Product Change Notification / SYST-28PKOP667

ERRATA - MEC170x Silicon Errata and Data Sheet Clarification

MEC170x

Silicon Errata and Data Sheet Clarification

FIGURE 1: HIGH IBAT CURRENT DURING COIN CELL INSERTION

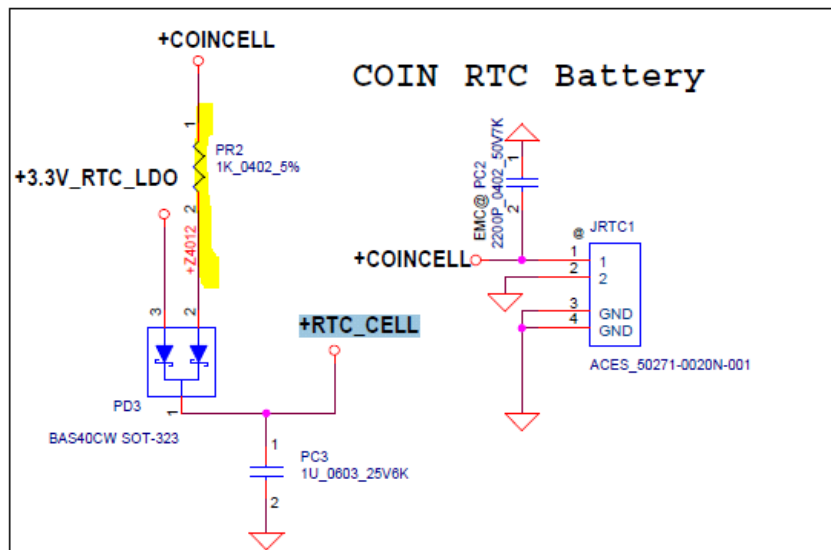
There could be a high I_{BAT} current on new coin cell insertion. During initial VBAT power rising, the VBAT circuit can enter a high current state causing a voltage drop across the 1K UL resistor. This affects all 128 and 144 pin packages. This issue is not present in the 169 pin packages.

- Under these conditions, the VBAT power on can stall in this high current state, with the VBAT on device pin between 0.7 and 1.2V.

When inserting the coin-cell follow the below procedure.

Insert the coin cell and then apply VTR (i.e +3VALW). This enables VBAT low-power operation. A high I_{BAT} will not return on subsequent VTR power cycles.

Referring to the RTC Battery circuit shown in [Figure 1](#), applying VTR via the +3.3V_RTC_LDO signal, powers RTC_Cell (which is connected to VBAT of MEC170x) directly (without a series 1k resistor and hence no IR drop from the applied VTR), raising VBAT (RTC_Cell) to greater than 2.0 volts. This takes VBAT out of the “high current” region discussed above enabling normal VBAT low power operation.
